AMENDMENT OF SOLICITATION / MODIFICATION OF CONTRACT

1. AMENDMENT/MODIFICATION #1		2. EFFECTIVE DATE 7/9/2018	
3. ISSUED BY PURCHASING SECTION WMATA 600 5th Street N.W. Washington, DC 20001		4. ADMINISTERED BY (If other than block 3) Margarita Rodriguez, Contract Administrator

SUPPLY OF METRO BOX

Solicitation IFB No.: FQ18142/MDR

Figure 4 – BDA Rack Layout

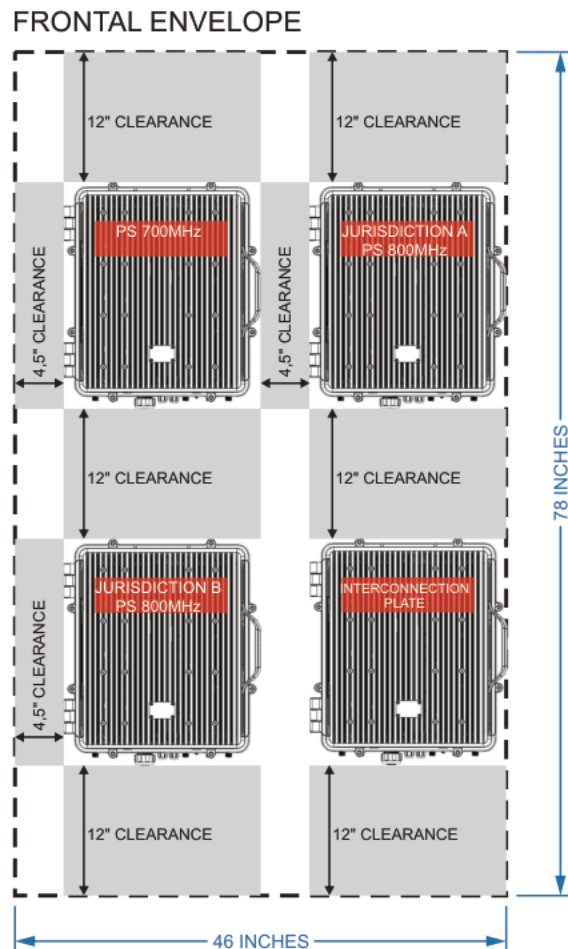
As per Figure 5, one mounting location in a BDA H-frame/19" open Rack will be occupied by an RF interconnection plate. This plate will house RF connection components shown in a diagram in Figure 5 below. This passive network consists of RF jumpers, bi-directional couplers, cross-band couplers and other components required to connect the BDAs to the underground DAS.
